REMARKS

BULLMAN et al. - Appln. No. 09/665,594

ANNOTATED MARKED-UP DRAWINGS

FIG. 1

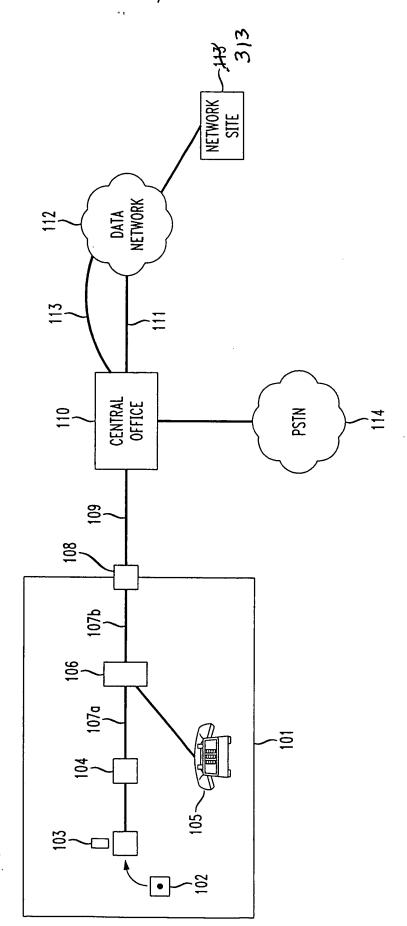
Figs. 1-5 were objected to for alleged labeling inconsistencies with the specification.

Moreover, the Office Action alleges that Figures 1 and 3 contain a reference to item 111 that is not mentioned in the description.

A proposed drawing correction is attached hereto for Figs. 1-3. Amendments to the specification are included herein to further correct any inconsistencies.

The Examiner is directed to, e.g., page 11, line 11.

The Applicants respectfully request the objection to item 111 in Fig. 1 and 3 be withdrawn.
